Tech Tip

Product Effected – 2006 Thru 2008 BBCV (Vision)

Hendrickson Tie Rod Ends

S07MC
SERVICE BULLETIN

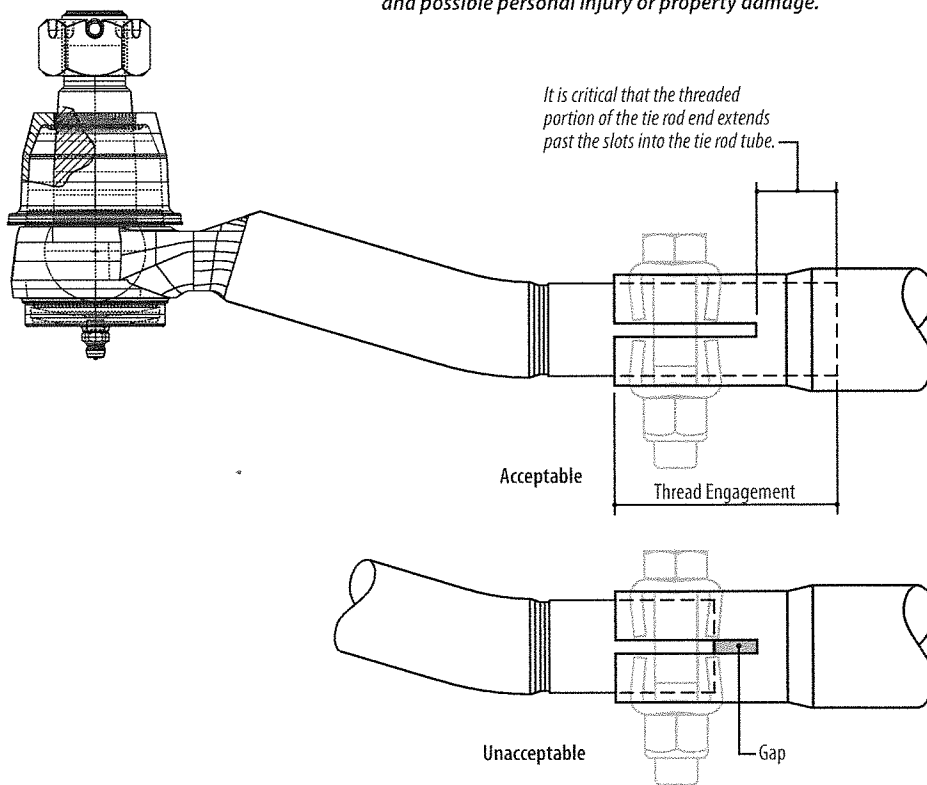
The tie rod assembly on Hendrickson front axles used on all Blue Bird Visions has undergone two changes since the introduction of the Vision. The changes were not reflected in Blue Bird part numbers because the tie rod assemblies are interchangeable. However, the First Generation tie rod ends are not interchangeable with the Second or Third Generation tie rod ends, resulting in different Hendrickson assemblies for individual subparts and assemblies. Blue Bird published S0705 Hendrickson Tie Rod Ends on May 14, 2007 to identify these changes and provide part numbers for our customers. It is possible, however, that a First Generation tie rod end (which had a long cross tube) may have been installed into a Second or Third Generation (which has a short cross tube) on chassis built after July 2005.

Inspect all Tie Rod Ends and/or Tie Rod End/Cross Tube assemblies, installed or purchased since July 2005. Inspect tie rod end thread engagement into cross tube. If threads do not extend past the end of the slot in the cross tube or if any gap exist between the tie rod end and the end of the cross tube slot, contact your Blue Bird Service Parts Representative for replacement parts.

WARNING: The threaded portion of the tie rod end must extend past the slots in the tie rod cross tube, failure to do so can cause component to fail causing loss of vehicle control and possible personal injury or property damage.

Second Generation Tie Rod Ends

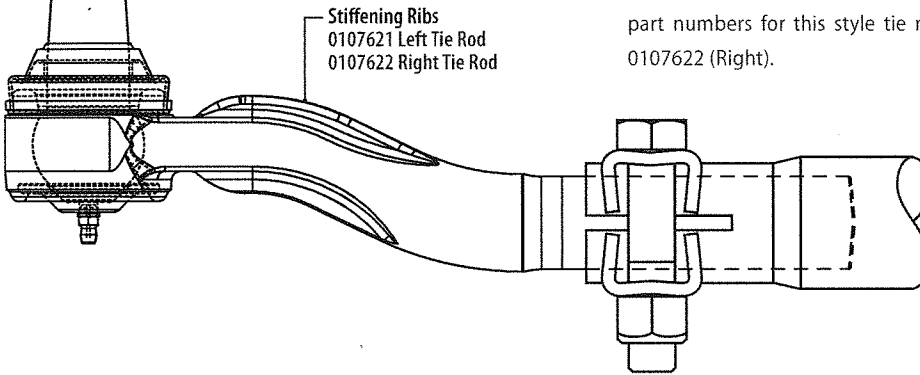
Second generation tie rod ends were used on Blue Bird Visions from mid July, 2005 to July, 2006. This tie rod end can be identified by stiffening ribs on the top and bottom of the casting between the threads and the rubber bushing. The Blue Bird replacement part numbers for this style tie rod end are 0107621 (Left) and 0107622 (Right).

Third Generation Tie Rod Ends

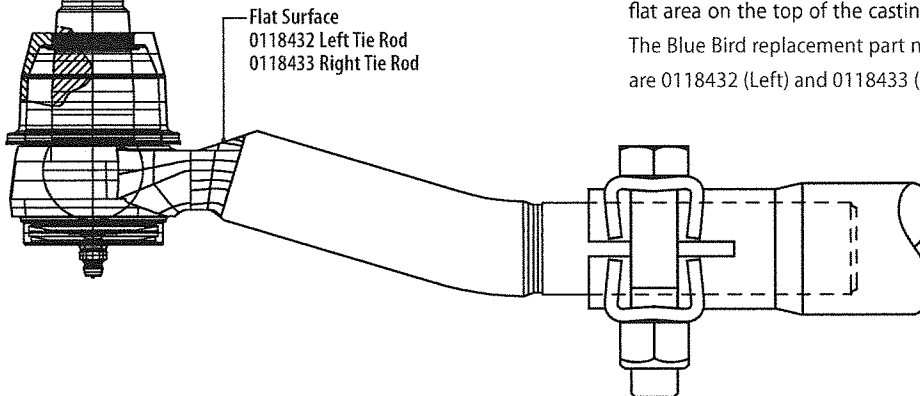
Third generation tie rod ends were used on Blue Bird Visions from July, 2006 to present date. This tie rod end can be identified by a flat area on the top of the casting very near the rubber bushing. The Blue Bird replacement part numbers for this style tie rod end are 0118432 (Left) and 0118433 (Right).

FIGURE 8-18

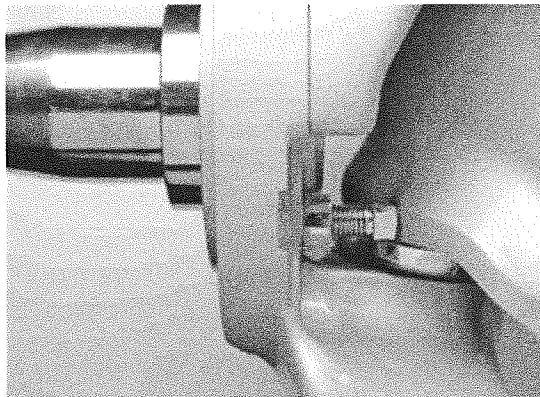
It is very important that the sides of the square head axle stops are set parallel to the axle beam to ensure a good contact point on the axle, see Figure 8-18.

5. Decrease the wheel cut by loosening the jam nuts and screw the axle stops out counter-clockwise.
6. Tighten the jam nuts to  40-60 foot pounds torque.
7. Measure the wheel cut and check for any interference with related steering components.
